**ADDISON AIRPORT
BUILDING REPORT**

Facility Information: **Facility Name:** 4700 Airport Parkway
Facility Contact: Lisa Pyles **Contact Phone:** 972-450-2878

Accessology Inspector Information:
Inspector: Karen Jackson **Date:** April 17, 2017
Email: Kjackson@accessology.com

Violation 2 - There is a 2-3/16" step up at the entry door.

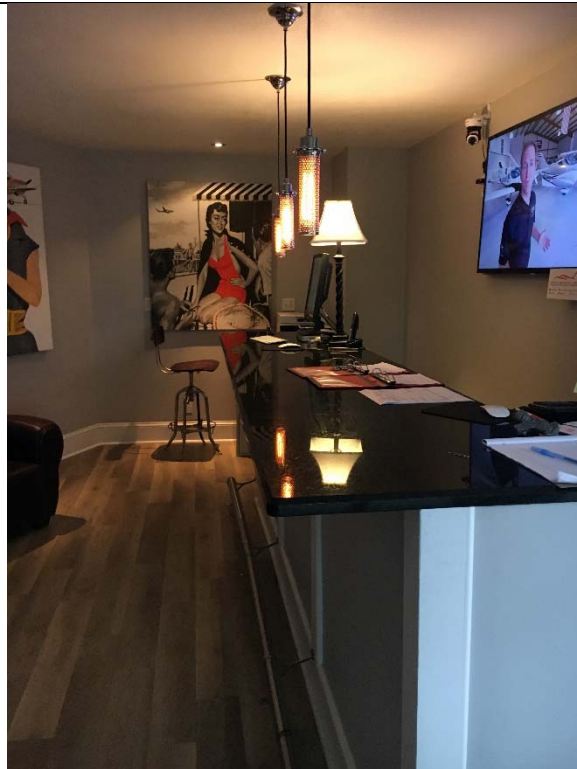
There is a 2-3/16" step up at the entry door.

Modify threshold to achieve a smooth transition at the entrance.
